## **VILLAGE OF CALEDONIA UTILITY DISTRICT MEETING AGENDA**

**RE:** O'Malley Investments – 4526 Northwestern Avenue – Storm Water  
Management Plan & Grading Plan for Land Disturbance Permit Conditional  
Approval

**RE:** Prairie Pathways Phase IV Utility & Grading Plan Conditional Approval

The Caledonia Utility District and the Village of Caledonia have performed a review of the Subdivision Plan sheets for the proposed Button Bush Drive expansion (Phase IV) in Prairie Pathways. The Engineering Improvement Plan is dated October 18, 2021 and was received on October 19, 2021. Below is a summary of the review comments.

**STORM SEWER & PAVEMENT PLAN & PROFILE**

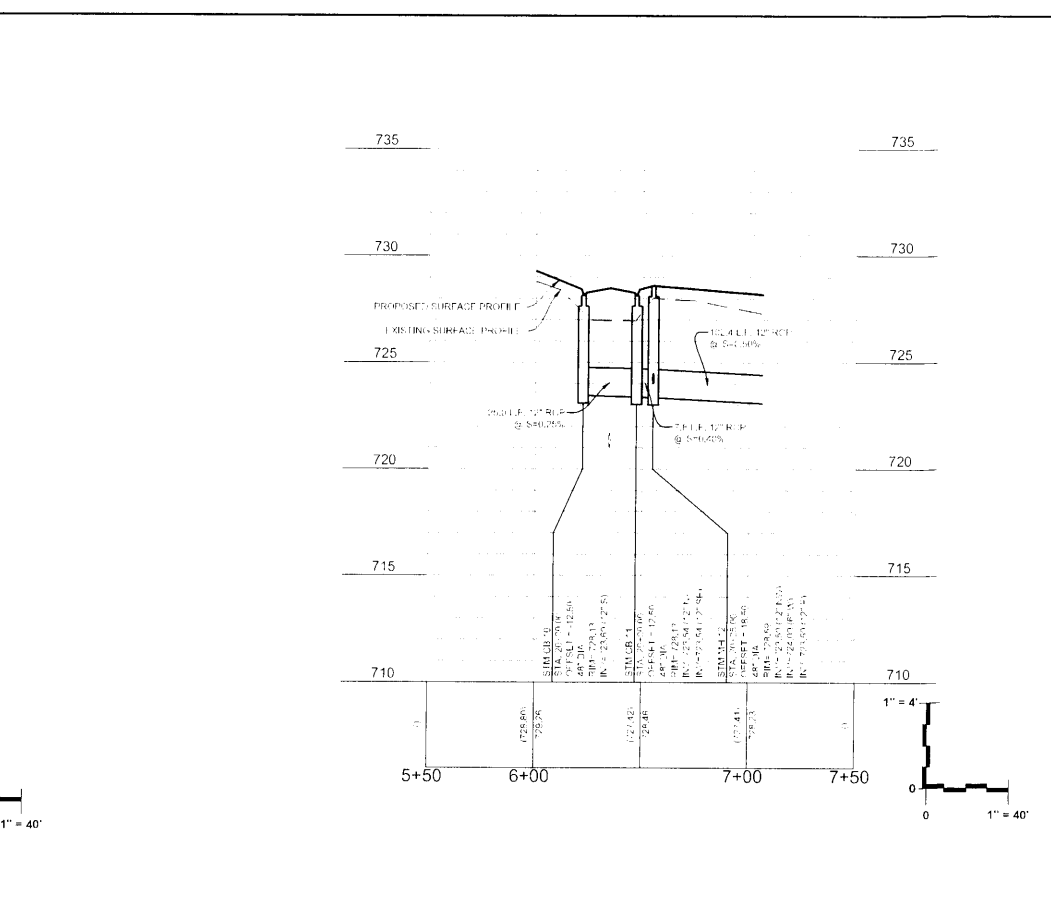
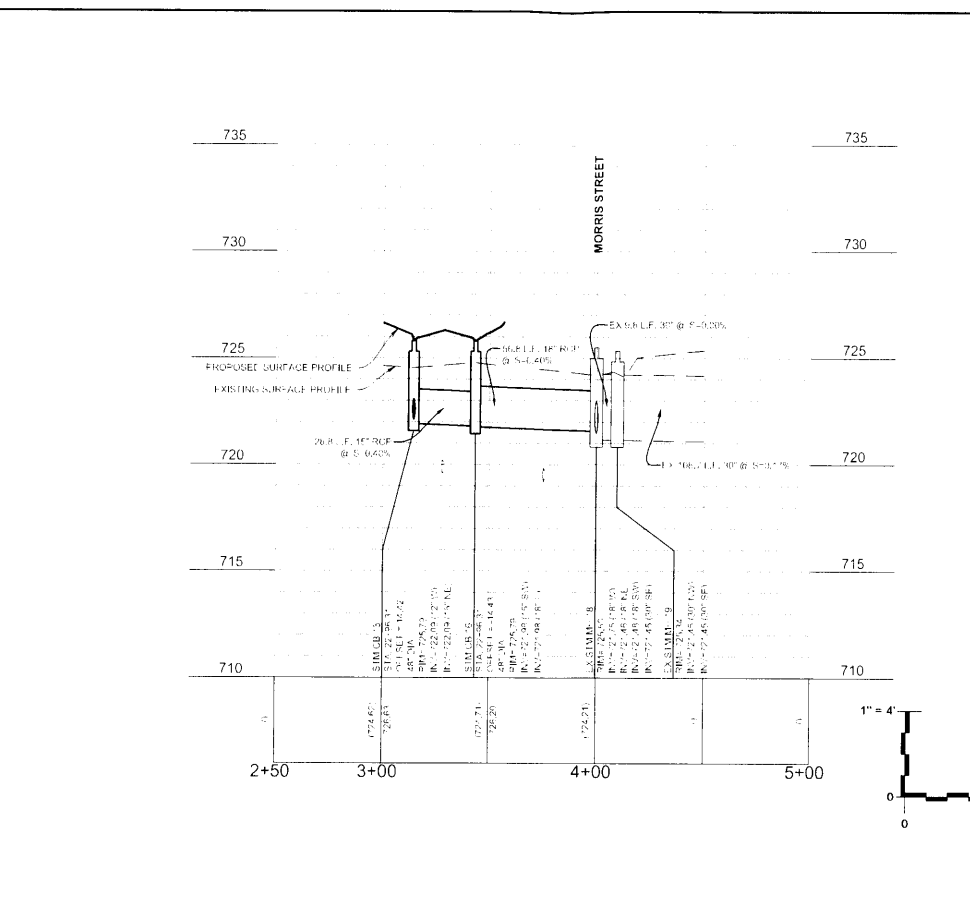
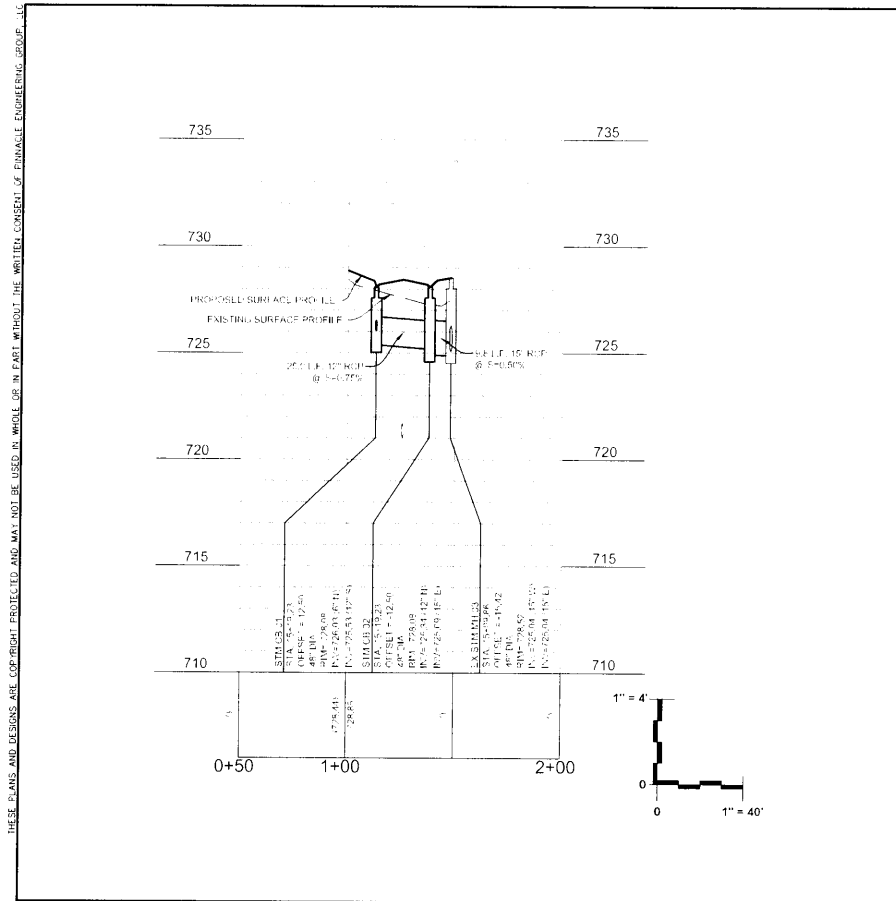
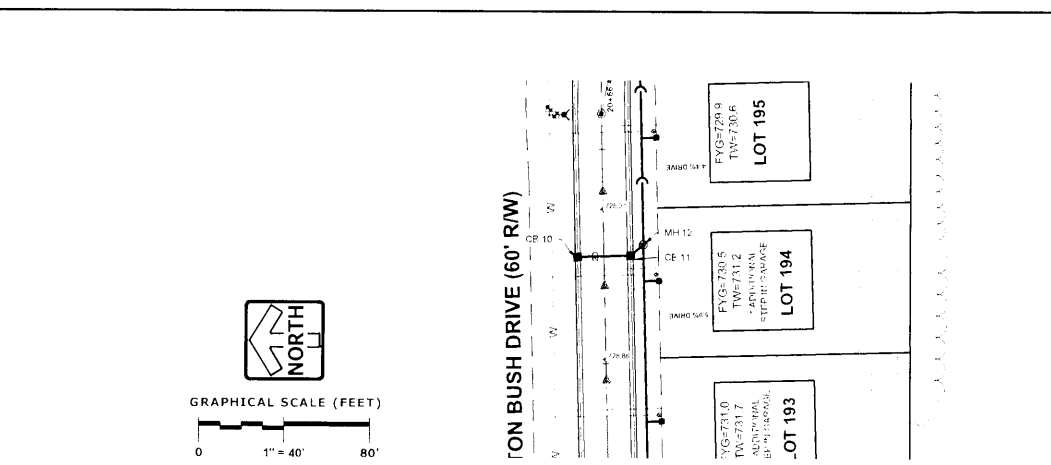
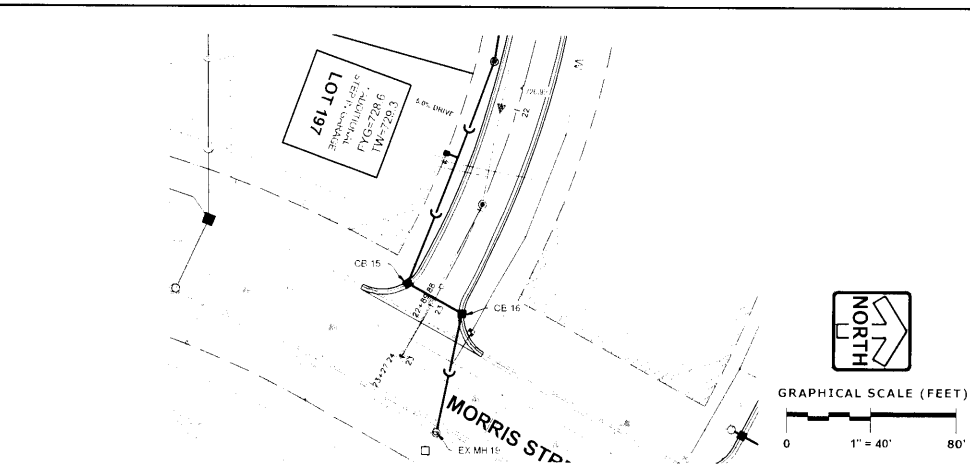
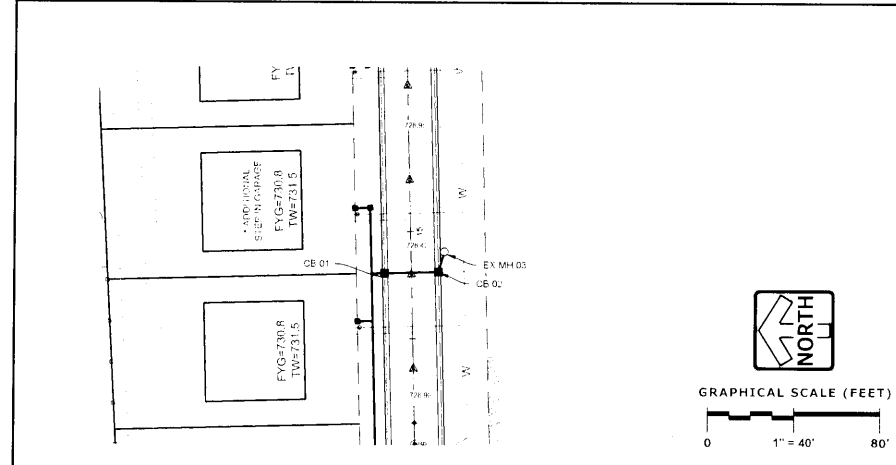
- On Sheet 9 of 13, the sump collection line out of CB01 will need to have a manhole added behind the back of curb for the change in direction OR will need to split the lines that run East and West, then install a sweeping curve with double 45° bends on both similar to what is done out of CB06.

- Review profiles for the sump collection system. Sheet 9 of 13. The profile for the line out of CB01 is shown lower than the downstream outlet. The profile for the line to the East is not shown.

**CONSTRUCTION DETAILS & SPECIFICATIONS**

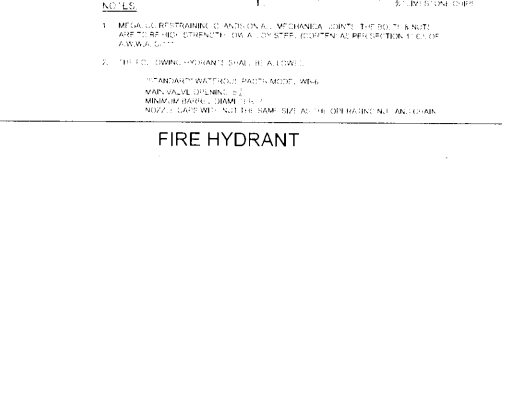
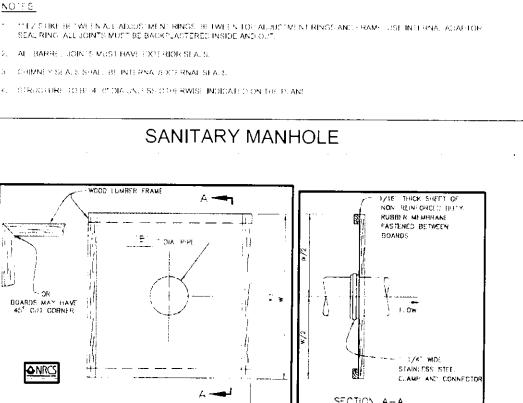
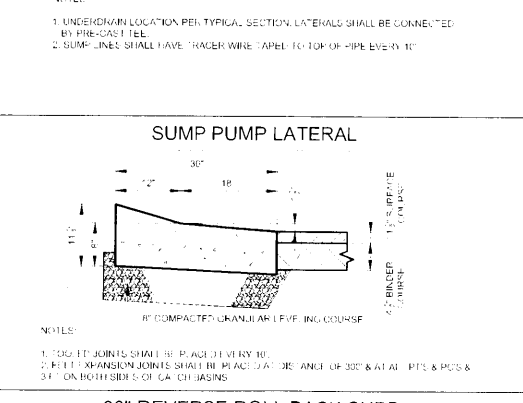
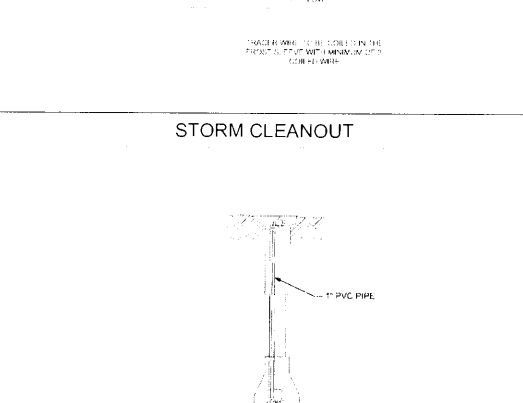
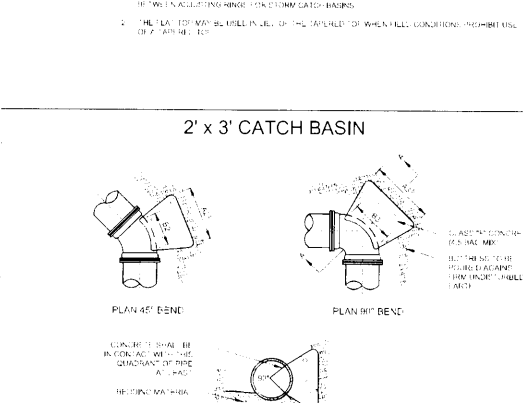
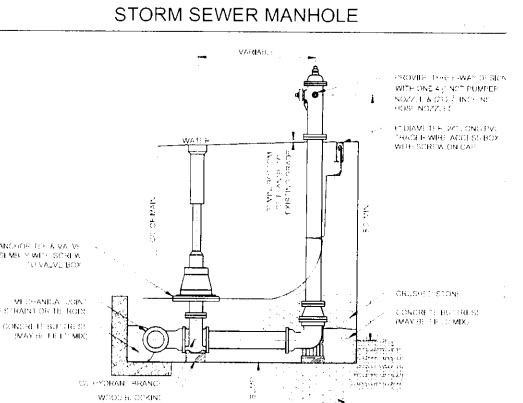
- **Sanitary Sewer**
  - On Sheet 12 of 13 Sanitary Sewer Manhole Detail. Will need to reference that the exterior of the sanitary sewer manhole shall have 2 coats of coal tar epoxy coating.

- **Watermain**
  - On Sheet 12 of 13 Tracer Wire at Gate & Butterfly Valve. The PVC conduit can be reduced to a ½" PVC line.
- **Storm Sewer**
  - Sheet 12 of 13 Remove the Anti Seep Collar Detail.

- Sheet 12 of 13 Clarify the diameter of the storm clean out pipes and frost sleeves.
  - Sheet 12 of 13 Clarify the diameter of the sump cleanouts pipes and frost sleeves.

- Sheet 12 of 13 Change casting on the 2' x 3' Catch Basin Detail back to Neenah Foundry R-3501-TB. I apologize for the confusion the 3501-R will not work.
